CRITICAL SERVICE BULLETIN

CSB 662A

SUBJECT: TCM D-2000 AND D-3000 SERIES MAGNETO CAPACITORS, P/N'S 10-382807, 10-382681, AND 10-382681-1

PURPOSE: To provide instructions for the replacement of affected capacitors, to revise overhaul replacement requirements for D-2000 and D-3000 capacitors, and to emphasize existing required safety practices.

FIGURE 1
Capacitor date code marking.

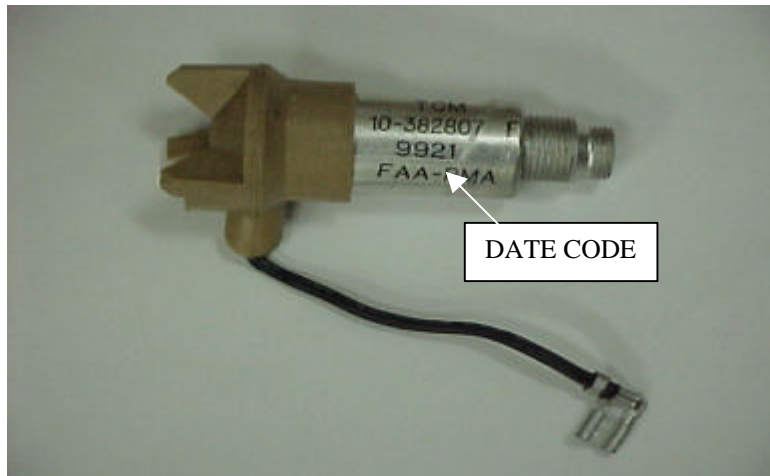
Capacitors are marked with a four-digit date code. The first two digits represent the year (99=1999, 00=2000), and the last two digits represent the week (01= first

week of the year, etc.). Therefore, date code 0001 is newer than date code 9942. See figure 1.

6. Install new capacitors with date code 9943 or newer, and replace attaching hardware and gasket (if used) in accordance with D-2000 and D-3000 Service Support manual, Form X42003 or later revision, SB651, and SB653.
